RECORD OF DECISION

**Kentucky Avenue Wellfield Superfund Site
Operable Unit 4 – Koppers Pond
Chemung County, New York**

**United States Environmental Protection Agency
Region 2
New York, New York
September 2016**

PHOTOGRAPHS

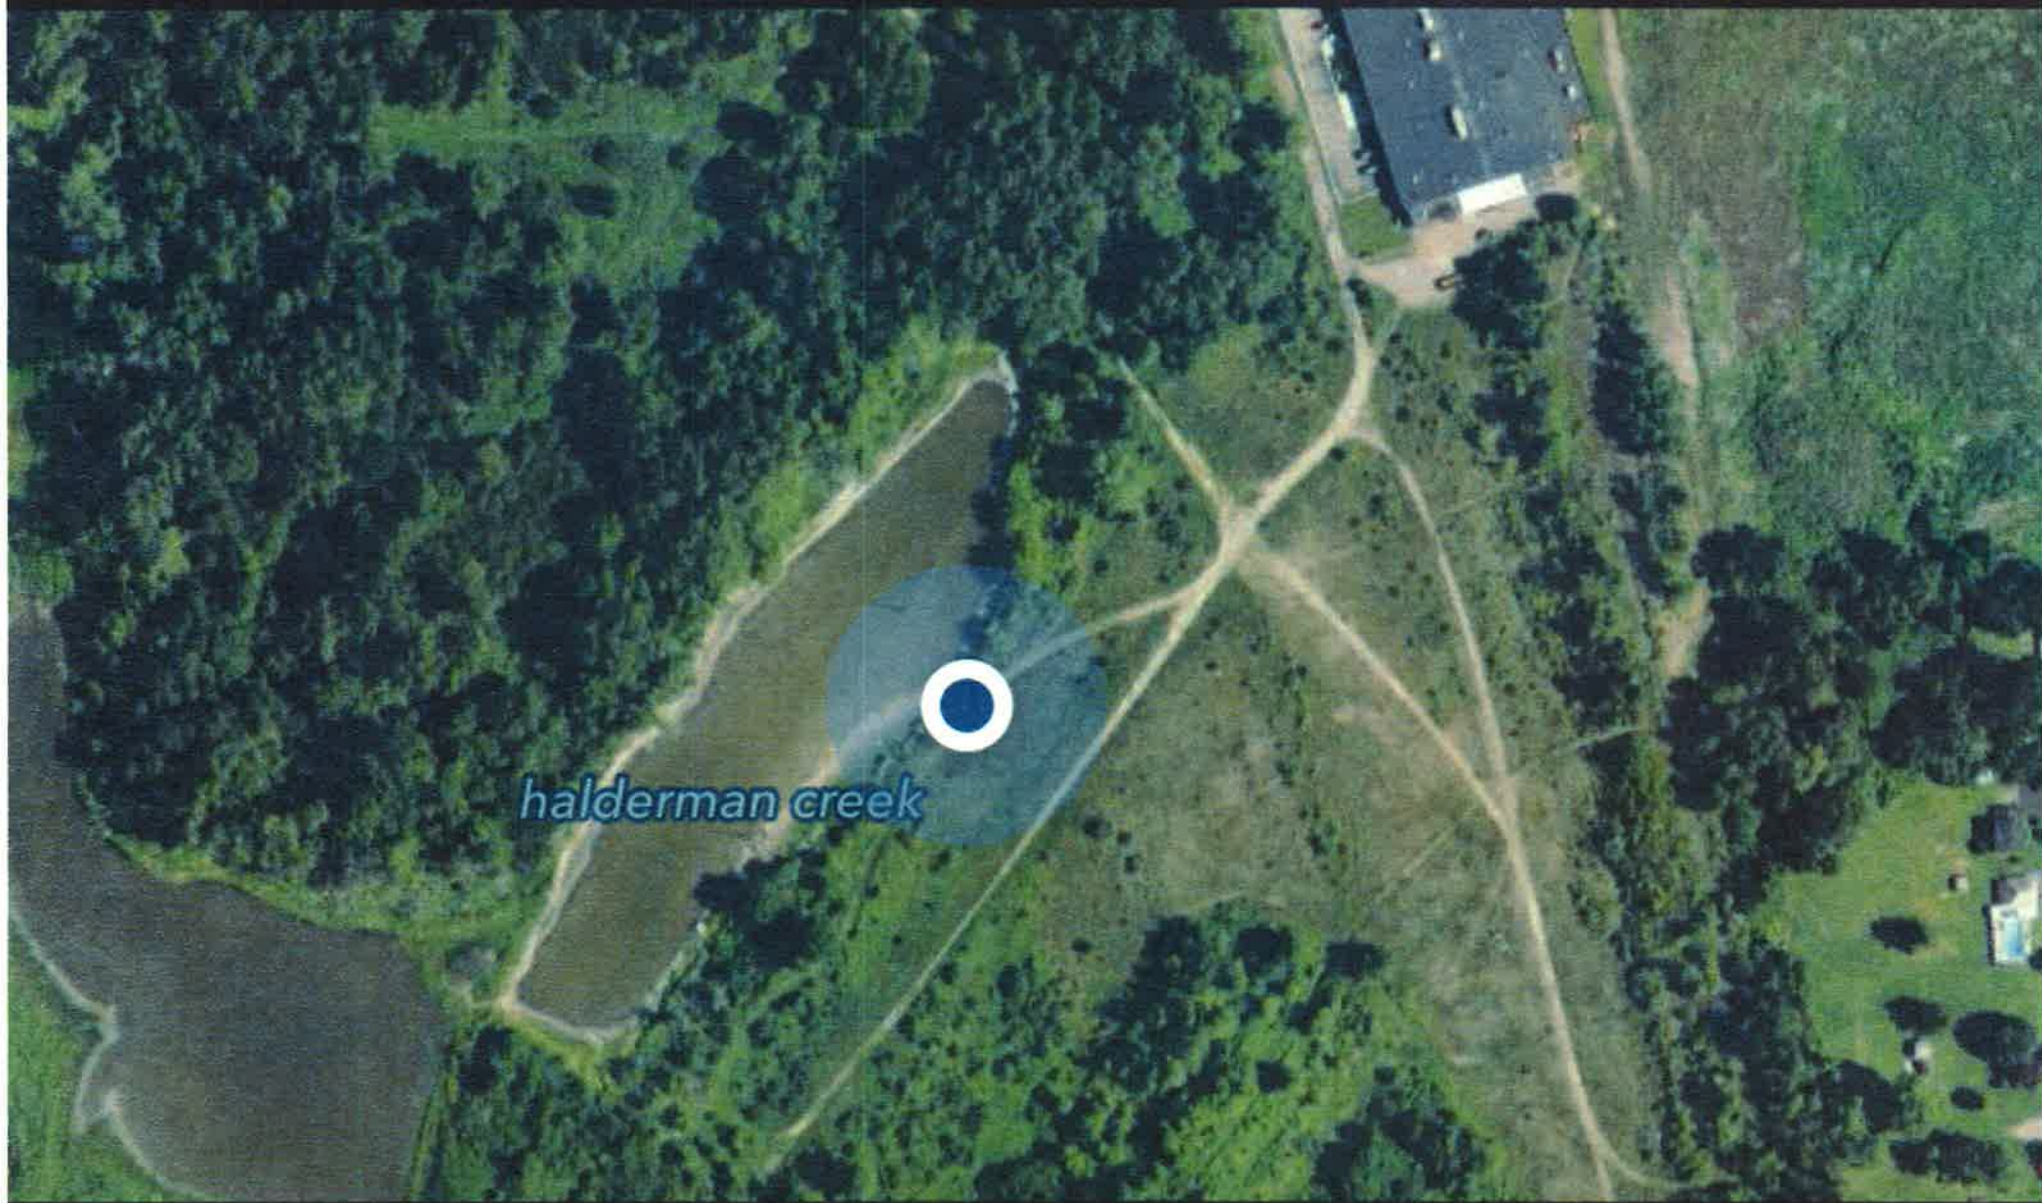
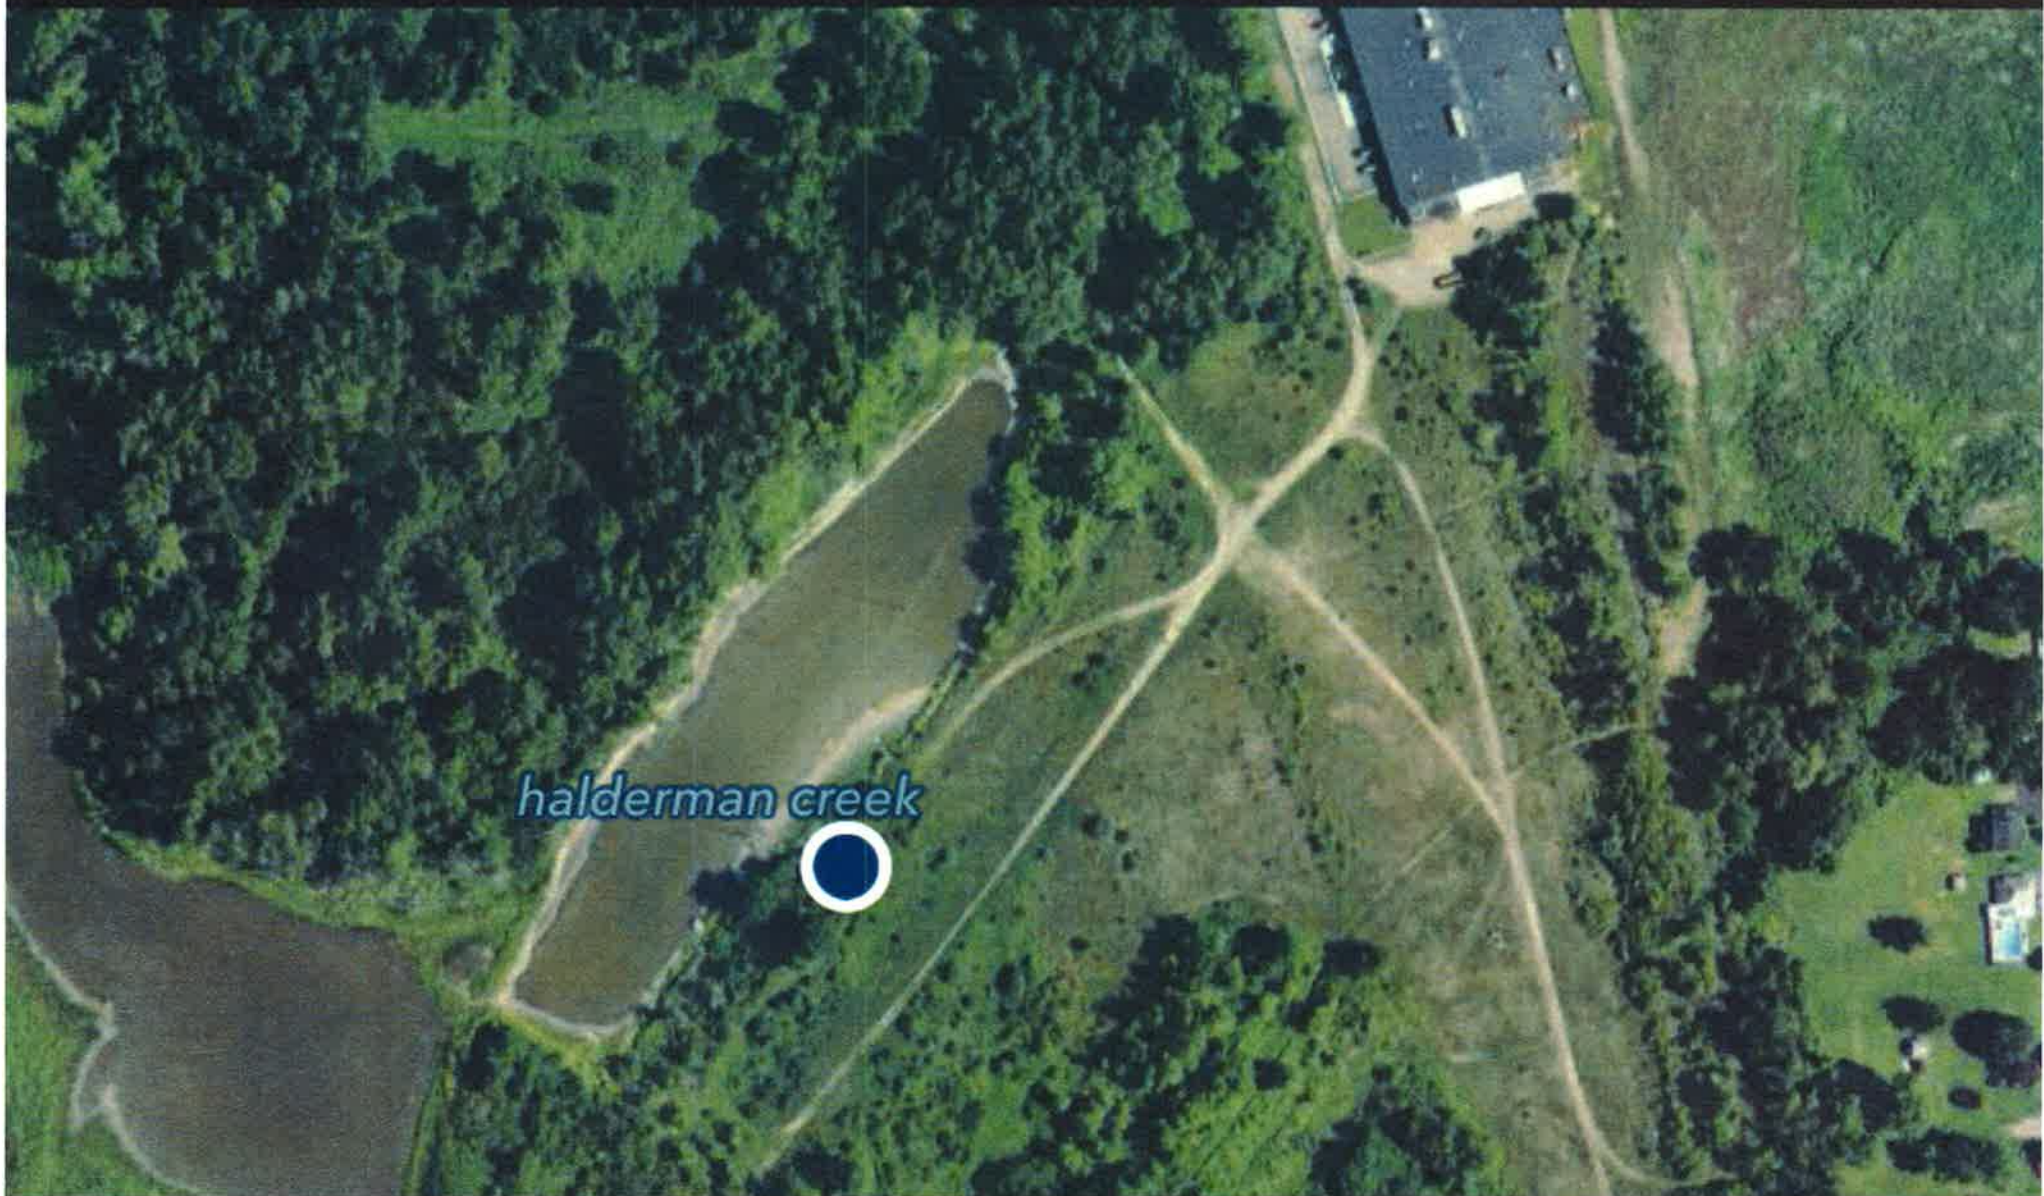
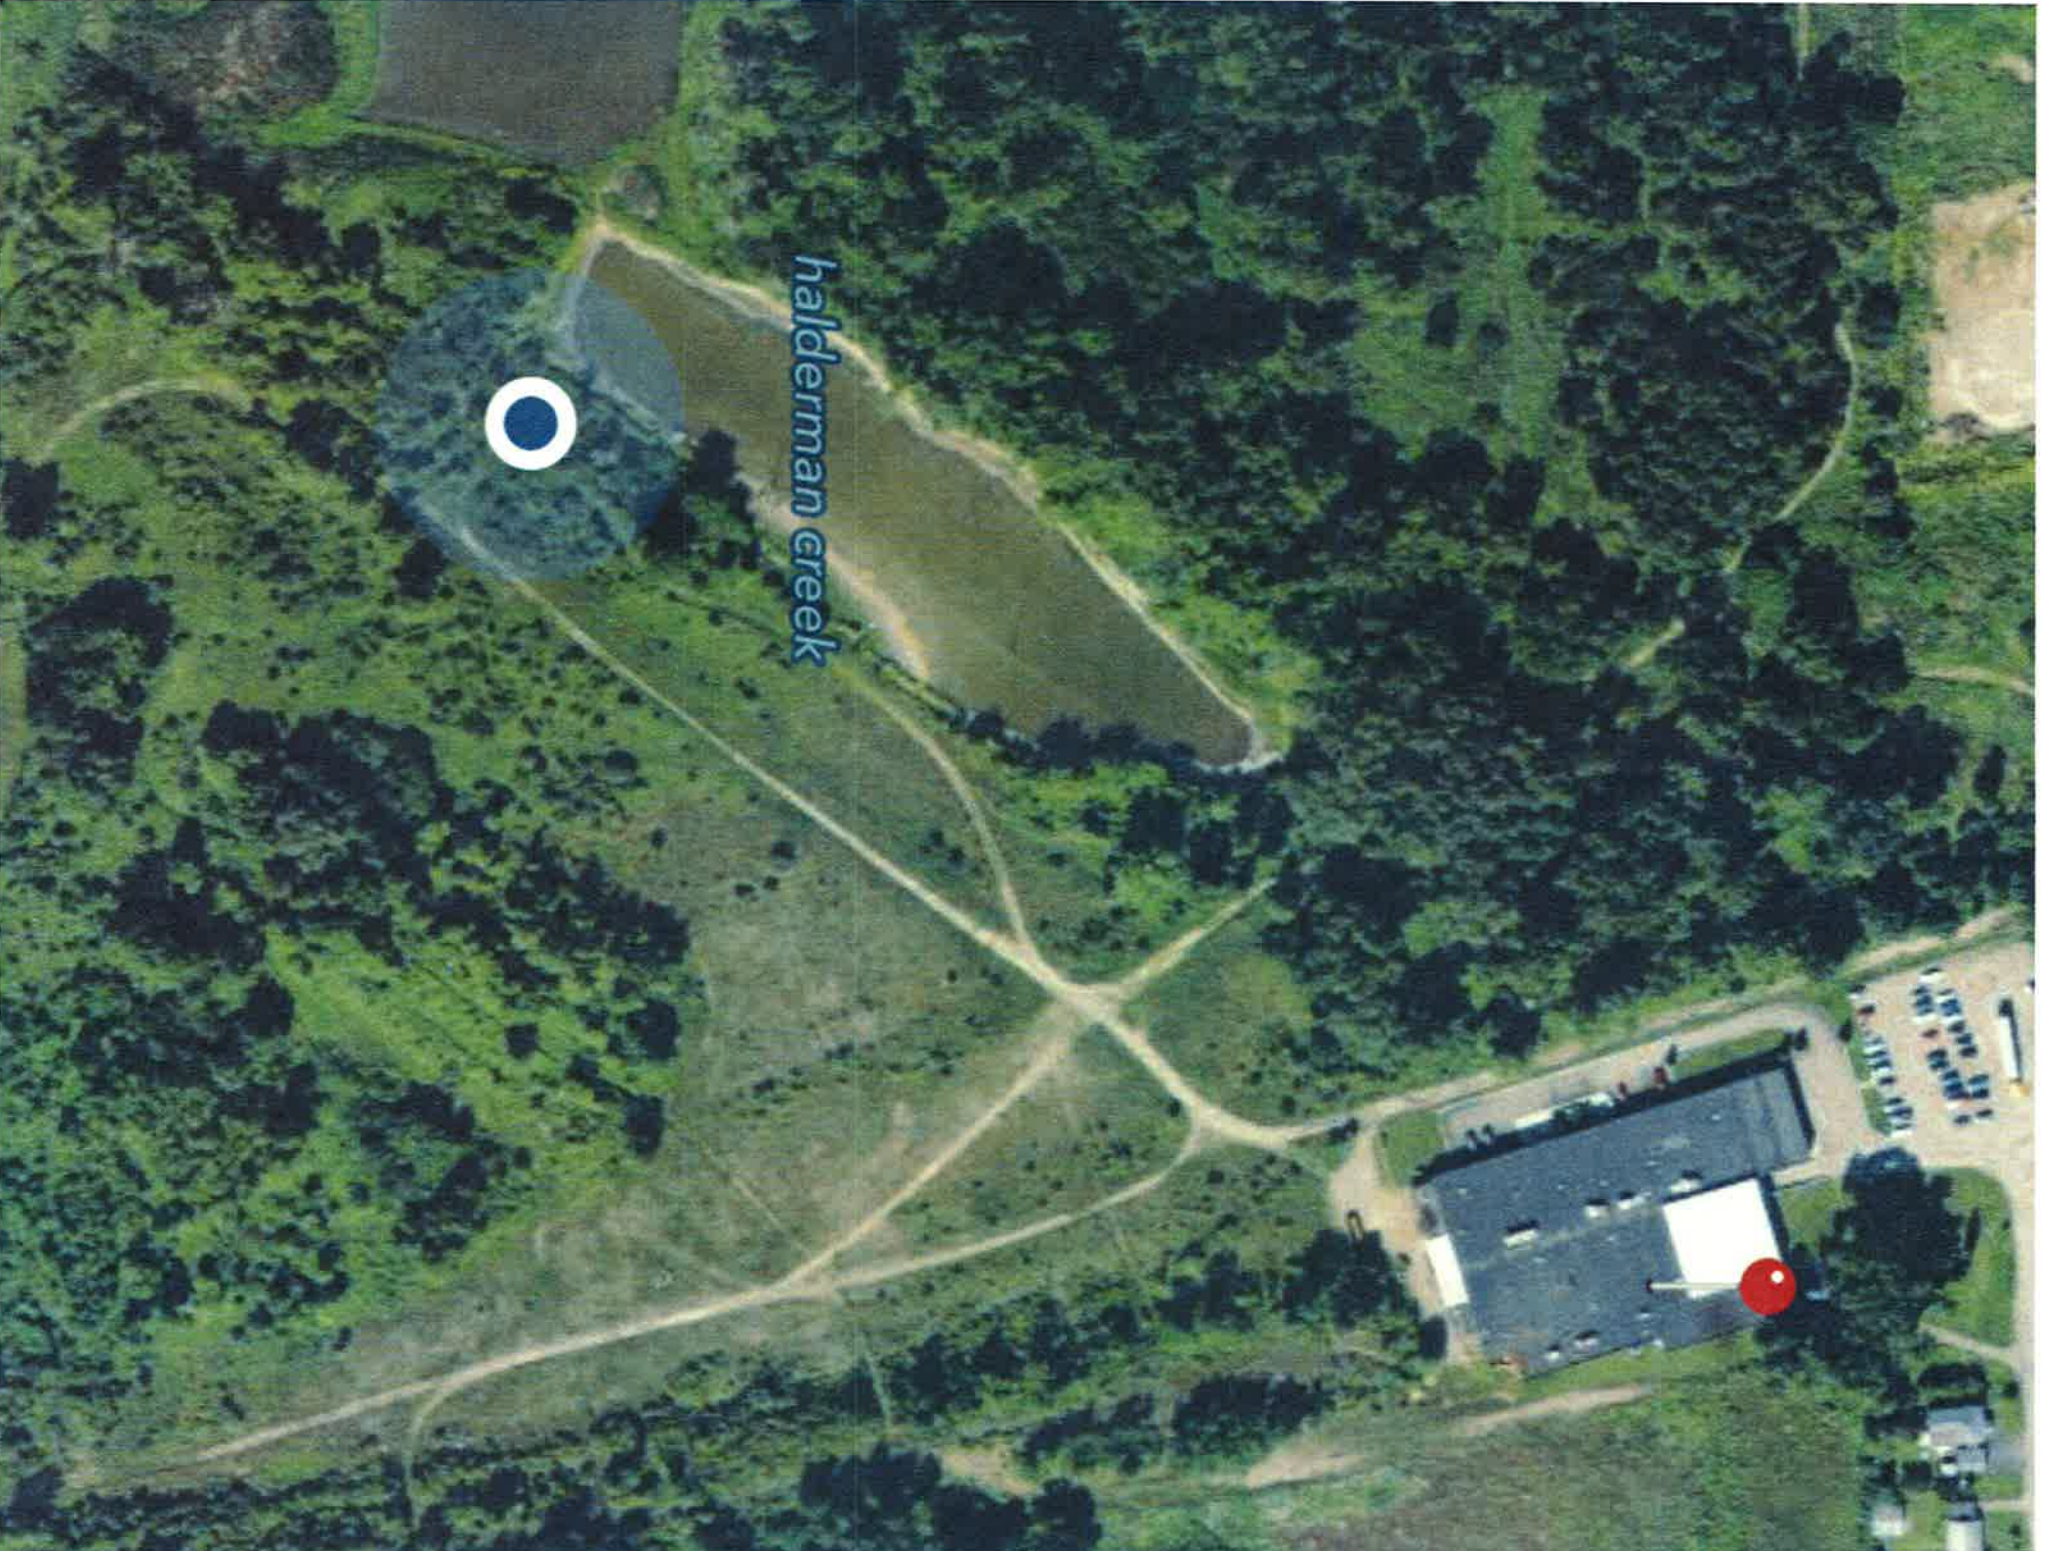
Comment # 1: CBS Corporation (CBS) and Beazer East, Inc. (Beazer) commented that EPA's selected remedy should not include measures meant to address or mitigate against fish consumption, since no visible fish population currently exists or will exist in the future at Koppers Pond. The commenters state that the only scenario whereby Koppers Pond would return to open water and support a fish population again would be through artificial means, such as the discharge of large quantities of water, over a long period of time, from the groundwater extraction and treatment plant located at the former Westinghouse facility and the restocking of the resulting pond. The comment further states that the treatment plant, which was constructed pursuant to the Record of Decision issued by EPA to address groundwater contamination at the Site, has been shut down since April 2014 and renewed operation is unlikely. CBS, as the party that implemented the groundwater remedy, states in the comment that it believes that the requirements of the OU2 Record of Decision addressing groundwater contamination at the Site have been fulfilled and that groundwater conditions at the former Westinghouse facility no longer require or justify operation of the extraction and treatment system. The commenters note that a recent substantial rainfall in the Koppers Pond area, and the resulting storm water discharge to the pond, resulted in little to no change in the pond hydrology. The commenters provide recent photographs showing the absence of an open water area and vegetation covering the pond.

Response to Comment #1: Consistent with EPA's guidance for conducting risk assessments to support remedy selection decisions, the human health risk assessment evaluated cancer risks and noncancer hazards under current and future conditions. As indicated in the Proposed Plan, under current hydrologic conditions in the pond, exposures to the pond including the ingestion of fish are not complete pathways. Furthermore, the Proposed Plan states that a July 2016 inspection of the pond revealed that the pond did not have any open water. However, resumption of the treatment system discharge or other significant discharges to the industrial drainageway could restore conditions that would once again support a fish population. As discussed in the HHRA, the cancer risk range and the goal of protection of an HI=1 were exceeded under potential future conditions.
